**Appeal Hearing
Site Plan Approval 23563**

Highway 7, Lake Echo, PID 40740276

October 30, 2023

Proposal: Construction and Demolition Materials Process Facility & Transfer Station.

Approved Site Plan

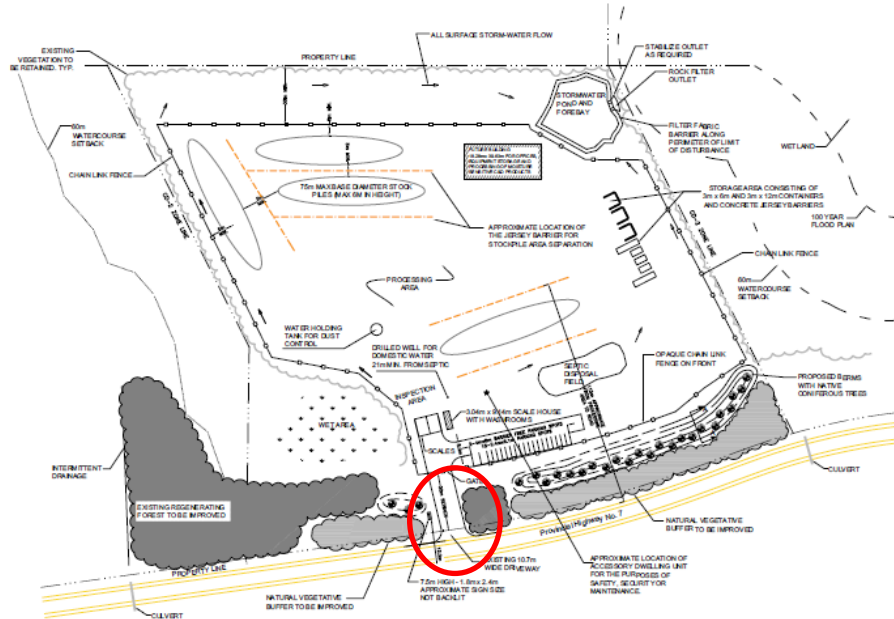
Criteria		Review Comment
(a)	<i>Driveway access to the site shall be located in such a manner to minimize land use impacts on adjacent land uses;</i>	The driveway is located near the center of the larger property, approximately 330 metres away from abutting property to the West and 625 metres away from the abutting property to the East. The driveway is approximately 10.7 metres wide which is designed to accommodate large sized vehicles.

(b)	<i>Separation distances shall be provided from any structure on the site and abutting residential or community facility properties to ensure the development does not negatively impact upon surrounding properties;</i>	The CD-2 zone portion of the property sits in the approximate center of the larger 47.83 acre property as shown on inset of the site plan. One large building for offices and equipment storage is proposed and located near the rear of the property and a smaller scale house building is located well behind the entrance gates.

Approved Site Plan

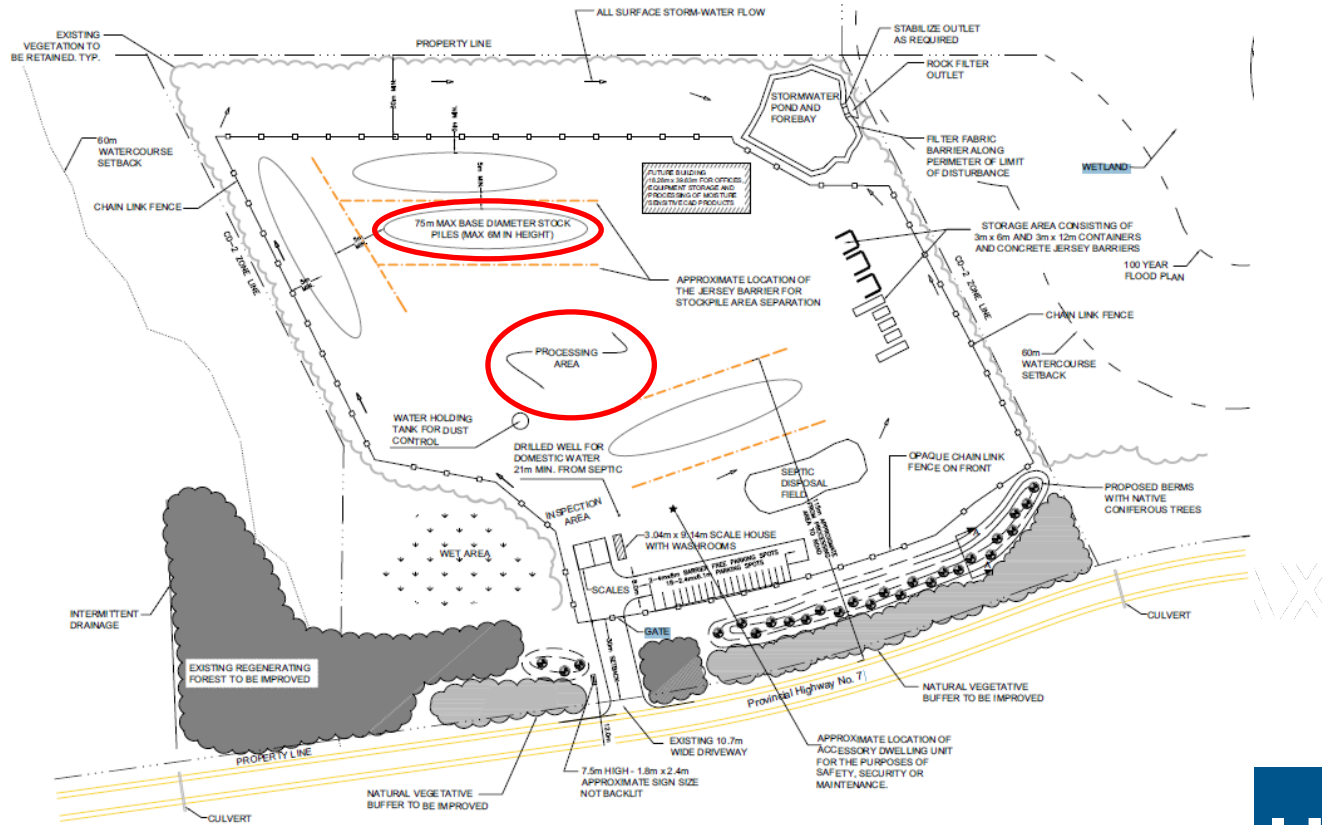
Criteria	Review Comment
<p>(c) <i>All off-street loading and unloading areas, stockpiles, processing areas, and parking facilities shall be located on the site such that no aspect impacts upon adjacent uses or streets and screening can be in the form of fencing, berms, vegetation, or a combination of elements;</i></p>	<p>All off-street loading and unloading areas are located within the fenced enclosure shown on the site plan. The stockpiles are located inside of the loading and unloading internal driveway. The processing area is located inside of the stockpile and container storage areas. The processing area is a minimum of 60 meters from both the front and rear property lines and from the CD-2 side zone lines. The parking facilities are located 30 meters from the street. Screening of all these components is provided in the form of the preservation of 30 meters of existing vegetation on all sides, planting of new vegetation along the front, opaque fencing along the front, and berms in the front as shown on the site plan. There will be a delineation between the stockpiling area and processing area with jersey barriers.</p>

Approved Site Plan

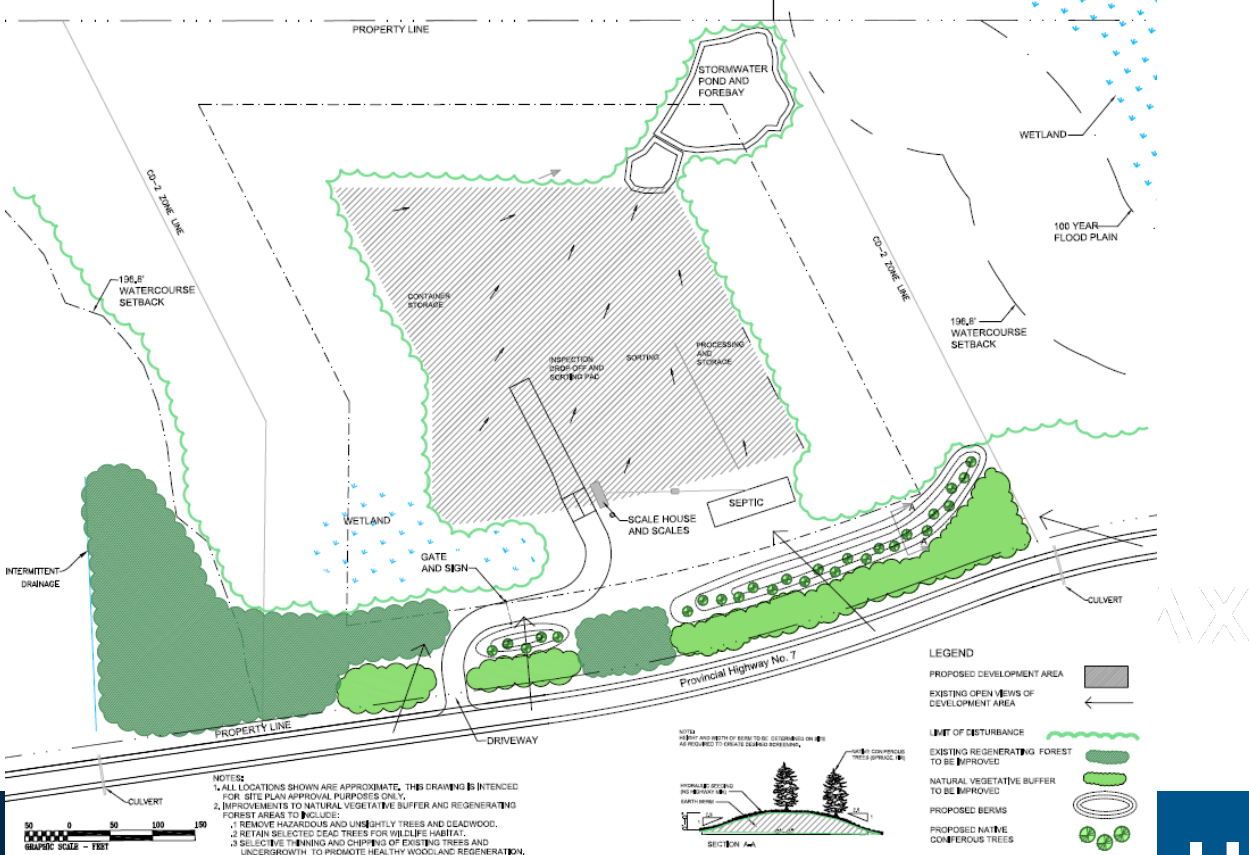
Criteria		Review Comment
(d)	<i>A landscaping plan shall be prepared that protects and minimize land use impacts on adjoining lands and the plan shall indicate the type, size, and location of all landscaping elements including the landscaping along the front of the property, to achieve the objective of the plan;</i>	The site plan incorporates the landscaping plan that was prepared by Gordon Ratcliffe Landscape Architects. The objective is to maintain and improve the existing vegetation on all sides of the operation and to provide berms with new plantings of coniferous trees along portions of the front of the site to provide screening from the street.

(e)	<i>Within any designated side and rear yards, existing vegetation shall be retained unless it does not provide for adequate screening measures;</i>	The proposal shows a 30 metre rear yard setback within which the natural vegetation provides adequate screening and shall be retained. Although the proposed operation is located within the center of the larger site, the proposal shows 30 metre side yard setbacks from the CD-2 zone line, therefore if the CD-2 zoned portion of the site is subdivided from the larger site in the future the setbacks requirements can be met. The existing vegetation within the 30 metre side yards of the CD-2 zone provides adequate screening and shall be retained.

Approved Site Plan

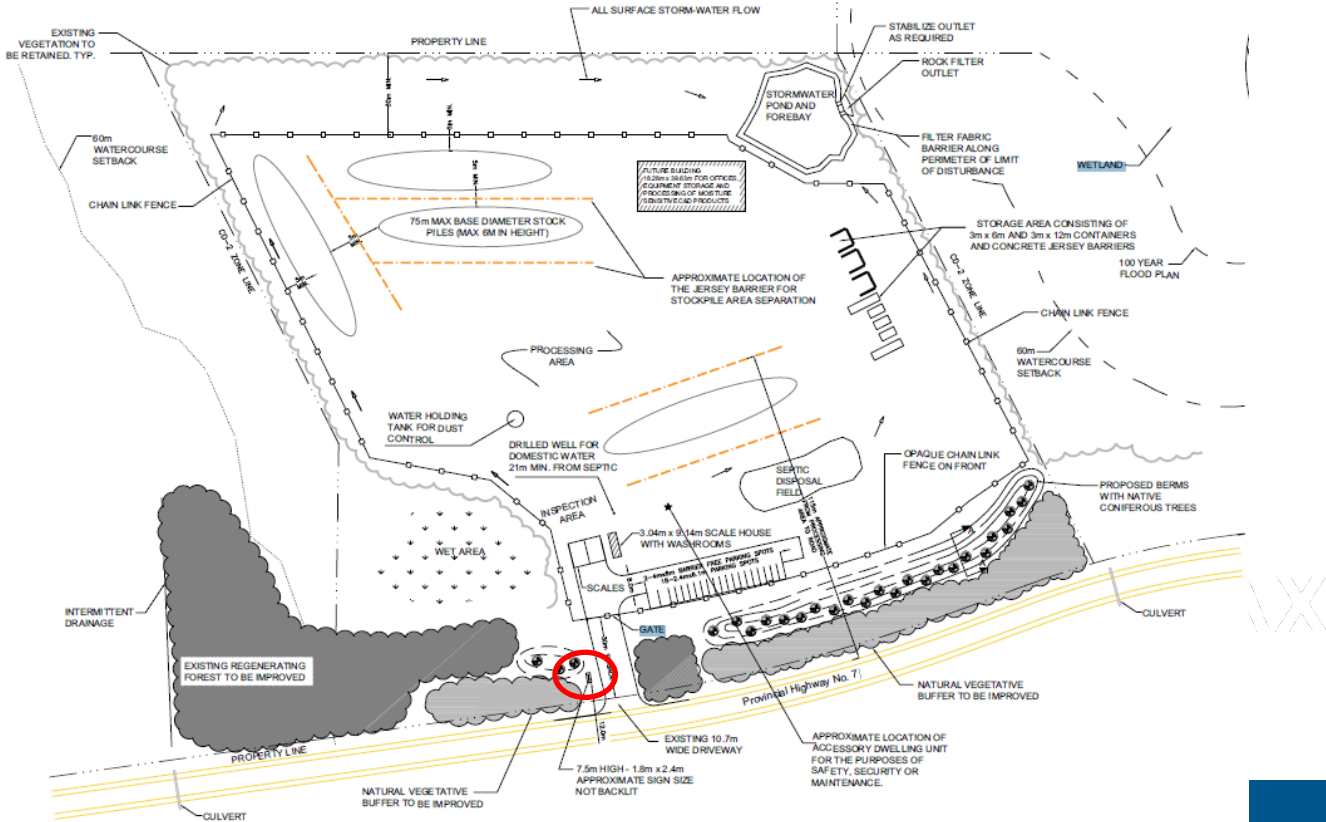
Criteria		Review Comment
(f)	<i>All outdoor lighting shall be oriented such that it is directed away from adjacent properties;</i>	All outdoor lighting shall be oriented towards the operation area and parking lot. No lighting will be directed toward the adjacent properties.
(g)	<i>All solid waste storage containers shall be screened from view from adjacent properties and streets;</i>	All solid waste containers are within the container storage area which will be fenced and screened by existing vegetation.
(h)	<i>Impact of the location, number and size of signs;</i>	One ground sign is proposed, which is shown on the site plan near the driveway. Currently it is proposed to be set back from the front property line by 12 meters and is proposed to be 7.5 metres in height with a sign face of 1.8 metres by 2.4 metres (4.3 square metres/46 square feet).

Approved Site Plan

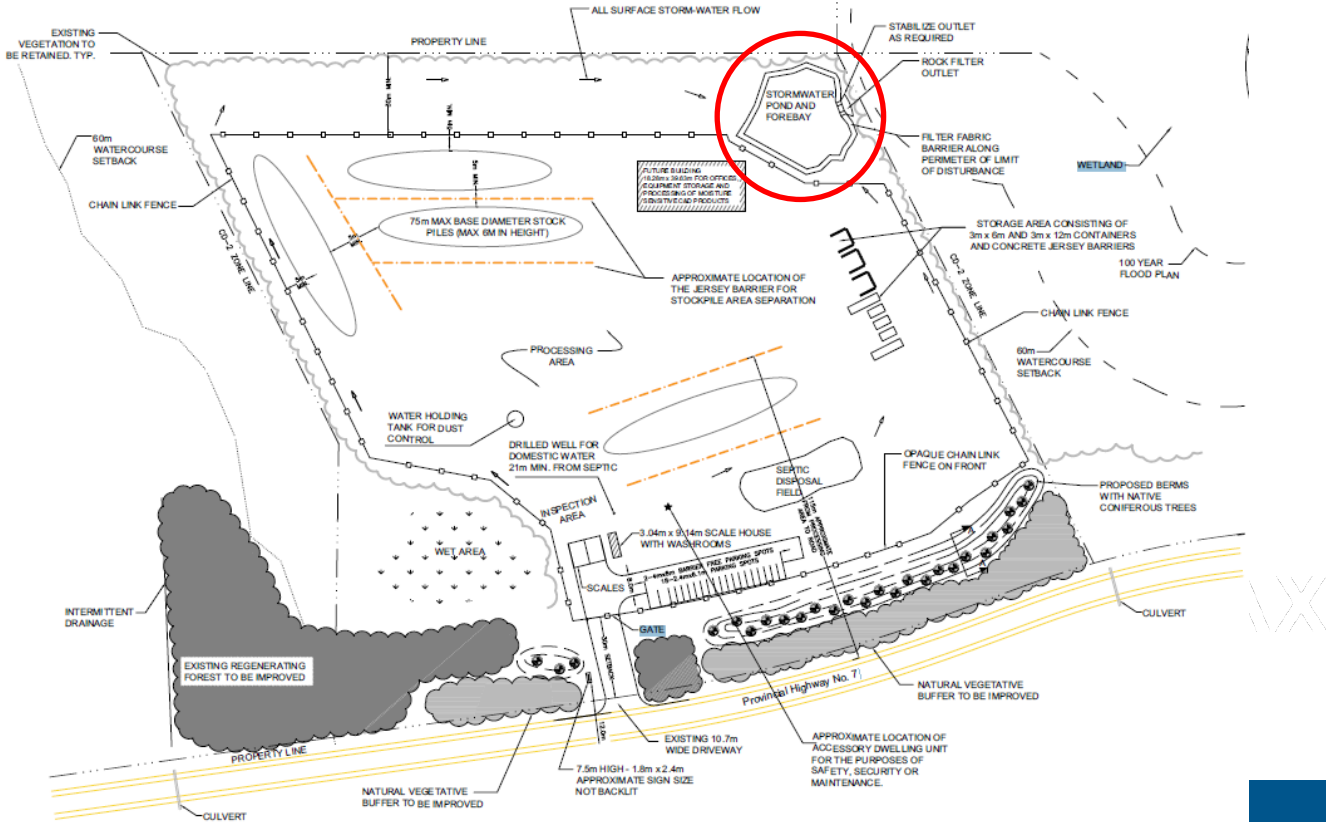
Criteria		Review Comment
(i)	<i>measures, including but not limited to lot grading, berms, shall be required to adequately address the management of stormwater and surface water; and</i>	The proposed stormwater management is shown on the site plan. Details on the construction of the stormwater pond and surface water channeling will be provided during the review of the required Grade Alteration Permit as per Bylaw G-200.
(j)	<i>Provision are established to ensure the operation and any required site improvements are maintained to a high standard.</i>	The operation will employ staff that will include an operations manager. The operations budget includes provision of dust control, waste disposal, maintenance of machinery, and overall site organization.
